ENGINEERING BULLETIN

Ref Document No.	EB16001	Issue No.	1
Subject	CT08 and CT10LP Lift Boom Stiffening Plate Upgrade		
Release Date	14 th April 2016

Purpose – Advise COALTRAM® CT08 and CT10LP owners/operators that an upgrade to the lift boom is now available.

Photo 2

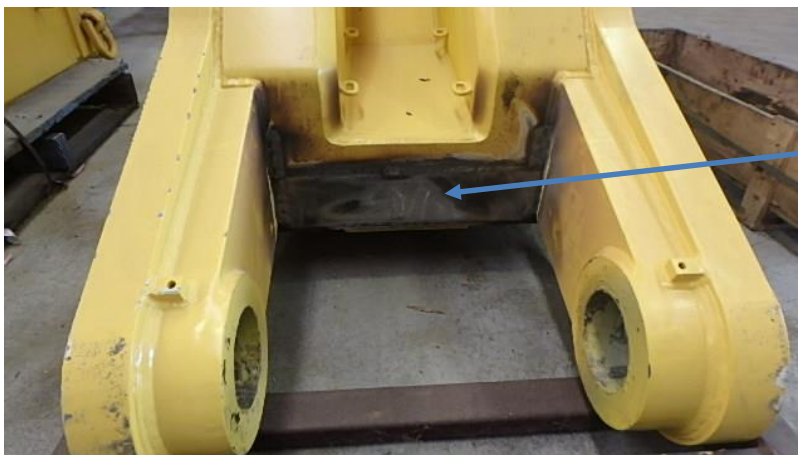
The boom lift cylinder pockets (Photo 2) cracked through a capping or sealing weld of the existing rolled stiffener. The upgraded stiffener (Photo 3) replaces the existing rolled plate stiffener and fills the void behind.

Existing stiffener (rolled plate)

Upgraded stiffener

The three upgraded stiffening plates provide additional support to the affected areas.
